CITY OF
West Linn

**STAFF REPORT
PLANNING DIRECTOR DECISION**

FILE NO.: DR-12-06

REQUEST: Class I Design Review for changes at the Robinwood Shopping Center (19133 Willamette Drive) for the benefit of Walmart, the principal tenant of the site. Proposed changes include:

Proposed configuration with new driveway

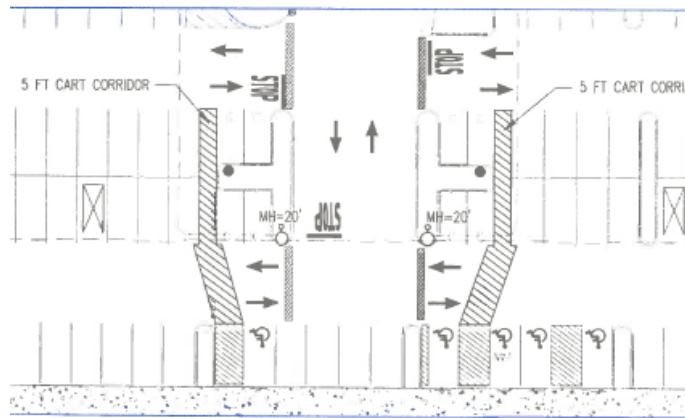
- The existing parking lot has a dead end near the Wells Fargo Bank which makes for poor parking lot circulation. The applicant proposes to remove six parking spaces to create a driveway for two way traffic.

7. The applicant proposes to install a new planter strip adjacent to the new driveway/aisle near Wells Fargo Bank (see photo "Proposed configuration with new driveway" above which shows the planter strip).

1. Site Plan. The improvements shall conform to the Proposed Site Circulation and Lighting Improvements plan C-10 dated 2/8/12, except as modified by these conditions of approval. All other proposed improvements shall conform to the location and materials specified in the applicant's submittal and supplemental submittal which are part of this record.

Figure 1: Locations for noise predictions.

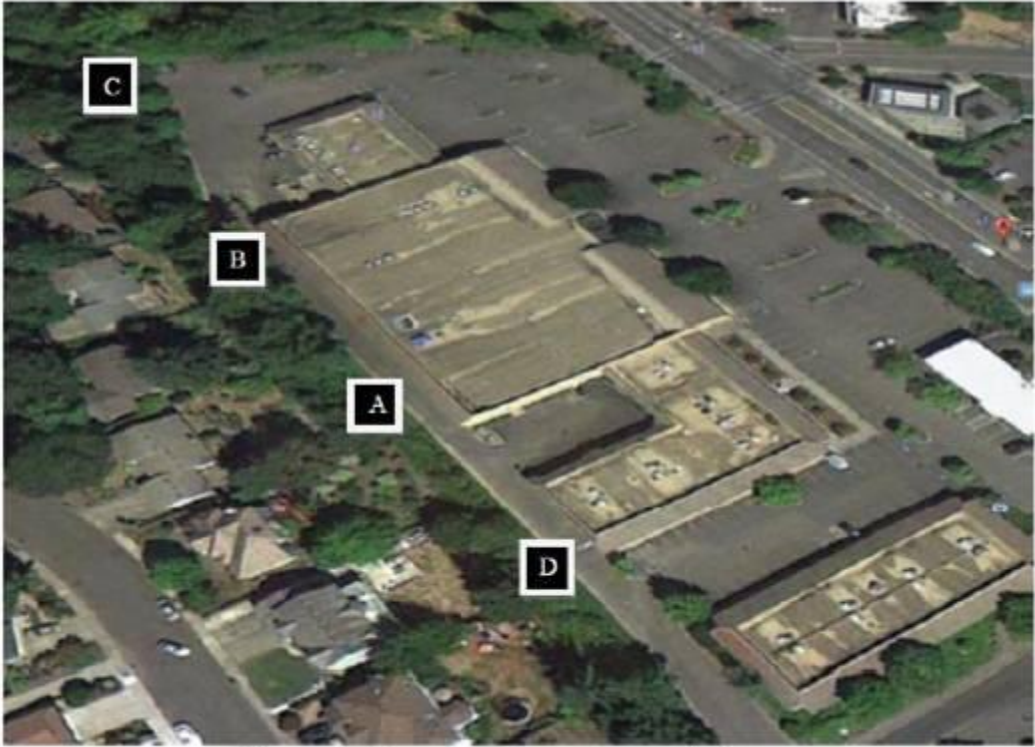
Regarding noise, staff identified two elements of this application which could produce noise levels in excess of existing or historic noise levels. Those noise sources would be the new rooftop HVAC and the proposed pallet recycling area.

To address the criterion, the acoustic engineer conducted a noise study based on sound monitoring along the rear or west property line at four roughly equidistant points: A, B, C and D, as shown on the photograph below.

The noise study found that noise mitigation will be needed for the pallet recycling area. The acoustic engineer specifically proposes a 90-foot long by ten-foot high CMU (concrete) wall to meet DEQ standards. The acoustic engineer found that the new rooftop HVAC equipment will meet the DEQ standards. His findings are reprinted below. No noise mitigation is required.

3. Noise. Pursuant to CDC 55.100(D)(4), if the City receives credible complaints about noise from the HVAC and/or the pallet recycling and storage area in the first year, the applicant shall provide a noise study by an acoustic engineer to demonstrate whether or not DEQ standards are met. If the study shows that DEQ standards are not met, a noise mitigation program, prepared by an acoustic engineer, shall be prepared and implemented to meet DEQ standards.
